Response to Discussion Initiators for KHNP/NRC Reactor Systems
Public Teleconference

October 27, 2015

Response to Discussion Initiators for KHNP/NRC Reactor Systems Public Teleconference: October 28, 2015

Figure 1. Pressurizer Level vs. Water Volume

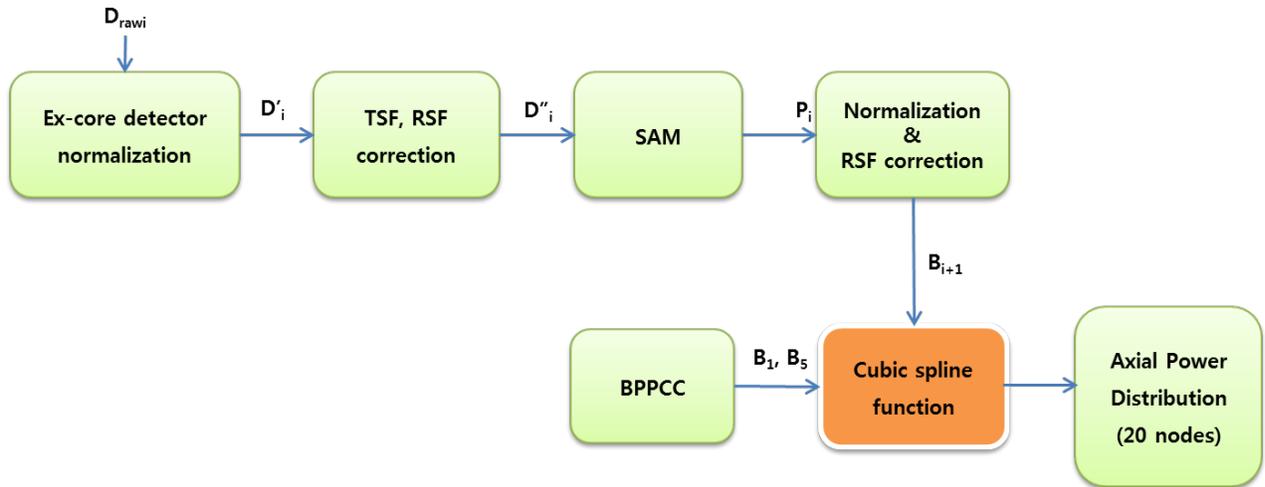
DCD Table 15.0-3 and Table 2.2-1 of the non-LOCA Technical Report provide the initial pressurizer water level range assumed in the safety analysis (i.e. inventory in terms of level). However, the individual events provide the initial pressurizer water volume. NRC staff needs to verify that the initial conditions are appropriate for each event.

- a. Provide an explanation, equation, figure, or table (equation would be best) to describe the conversion from pressurizer water level to pressurizer water volume.

The CESEC-III uses PZR water volume for calculations. Therefore, the initial PZR level condition for each non-LOCA event is provided as PZR water volume corresponding to the initial PZR level for the CESEC-III input. This PZR water volume is calculated by interpolation using the relevant data (PZR level vs. water volume) based on Figure 1.

Figure 3. Shape Annealing Matrix (SAM)

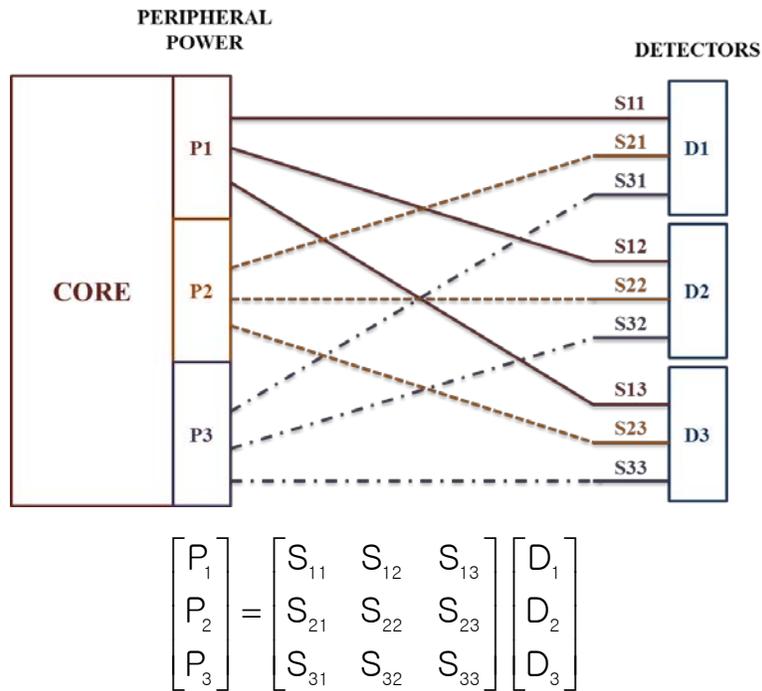
- a. The staff has been reviewing the related submittals and ERR documents but has not yet been able to gain a clear and consistent understanding of how shape annealing functions and related inputs are determined and used.
- b. Are there additional documents that could be submitted or added to the ERR that provide clearer and more comprehensive discussions of these topics?

The CPCS axial power distribution is synthesized from response of the three element ex-core detector string. Figure 2 shows the calculation flow of CPCS axial power distribution. SAM (Shape Annealing Matrix) and BPPCC (Boundary Point Power Correlation Coefficients) are applied to the normalized 3-level ex-core detector signals to give 3-level peripheral power integrals (See Figure 3).
